PRELIMINARY/FINAL DRAINAGE REPORT

MIDTOWN COLLECTION AT HANNAH RIDGE

FILING No. 3

Engineering Review

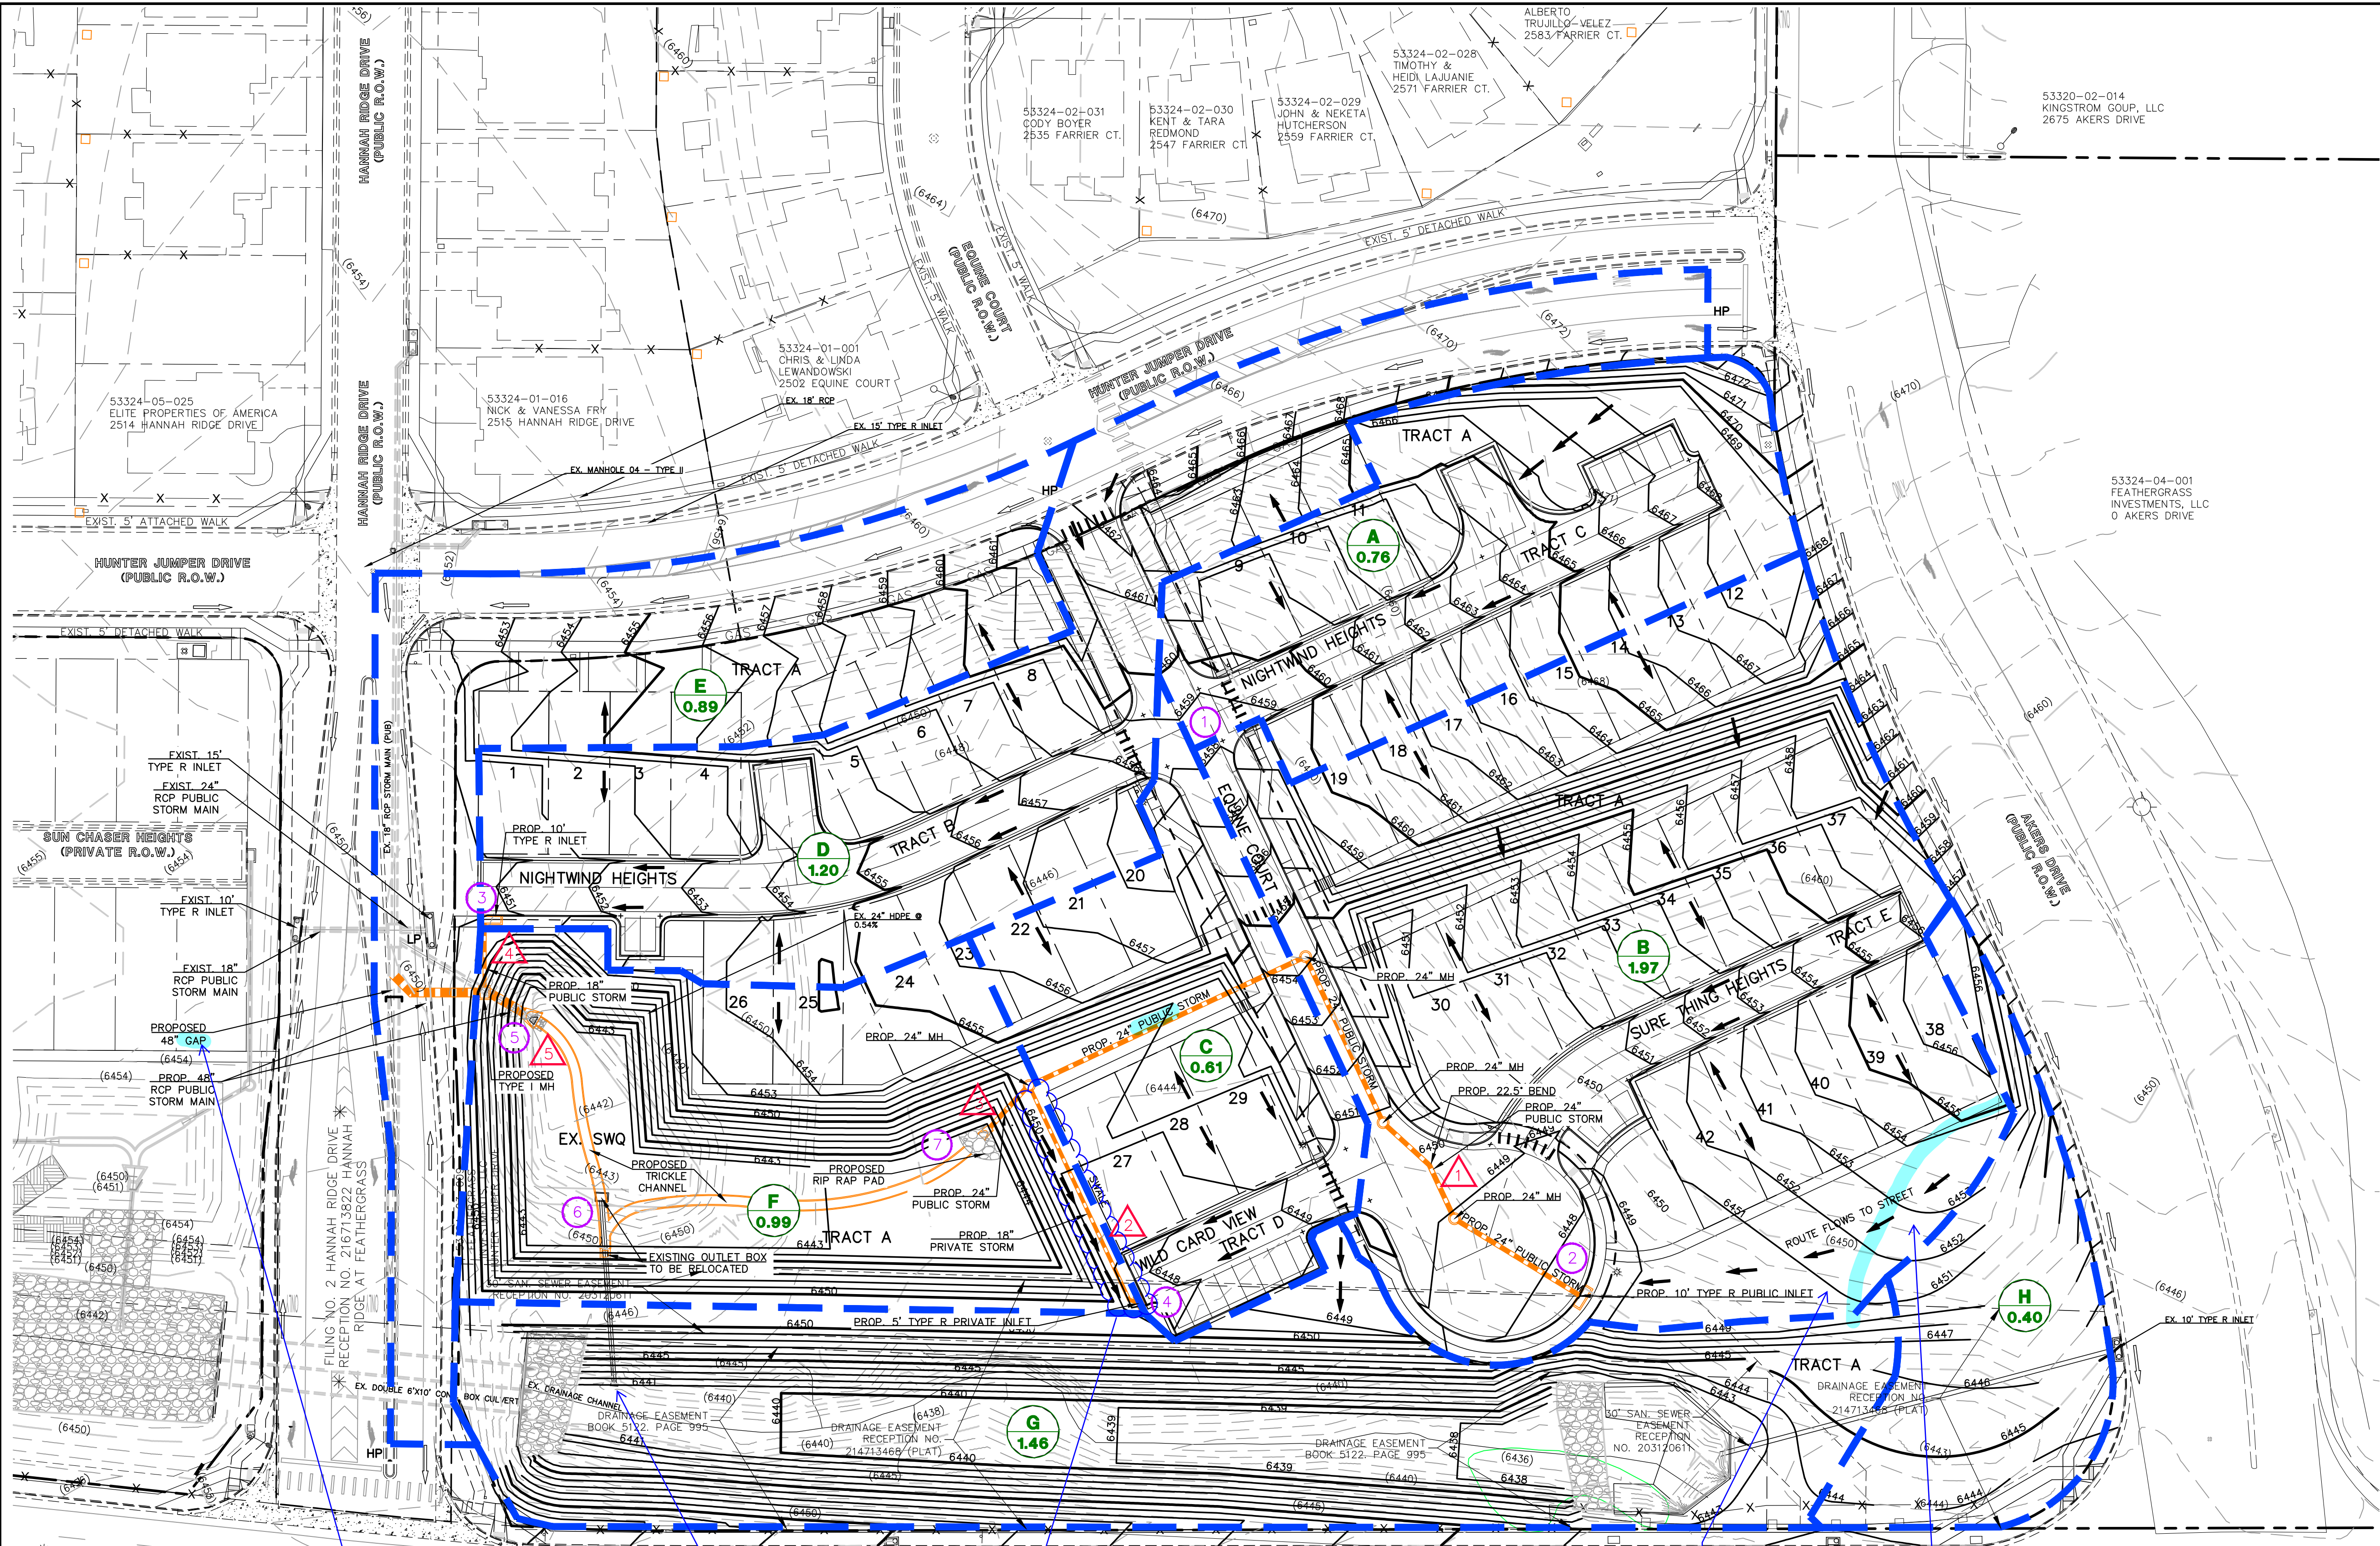
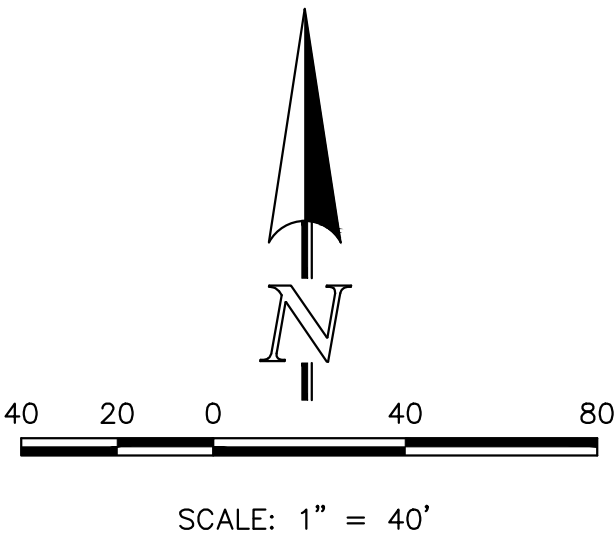
Provide Existing or overall Drainage Plan showing the entire drainage area to the FSD. This can be combined with the MS4 map requested in the comments.

What is GAP?

Show all maintenance access roads

clarify pipe and swale flow directions

How are flows routed to the west? Show berm or swale.
